Subject: Wisconsin Public Service Corporation
Kewaunee Nuclear Power Plant
Docket 50-305 Regulatory Suppl File C₇
Type of cement

PROJECT: KEWAUNEE NUCLEAR POWER PLANT

SUBJECT: SETTING TIME OF CONCRETE MIXTURE (ASTM C403)

FIGURE 1

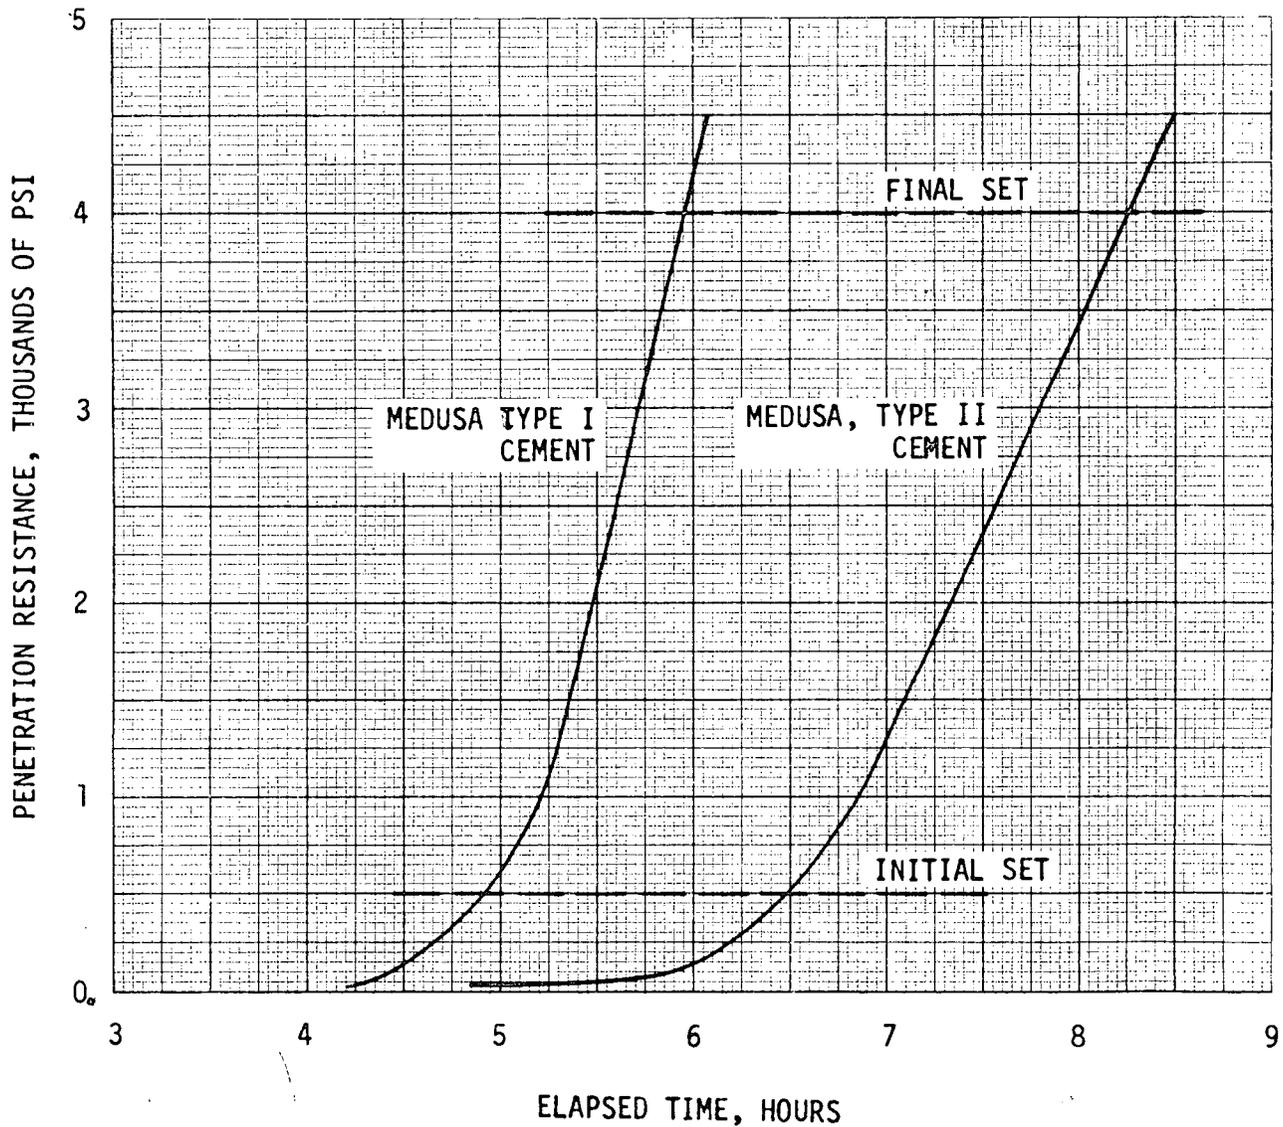
On Figure 1 is shown the time of set for the concrete mix being used on the Kewaunee Project. Final set occurs about 2 hours and 20 minutes earlier for the mix using Type I cement than for the mix using Type II.

To summarize, concrete can be made with Type I cement which is just as strong, durable and impervious as that made with Type II cement, except that under certain conditions the greater heat of hydration of the Type I cement could be detrimental to the final product. We propose to use either ASTM C-150, Type I or Type II cement, whichever is deemed to be best for a particular installation. The determination of which is best will be made by the design engineer on the basis of the considerations outlined above.
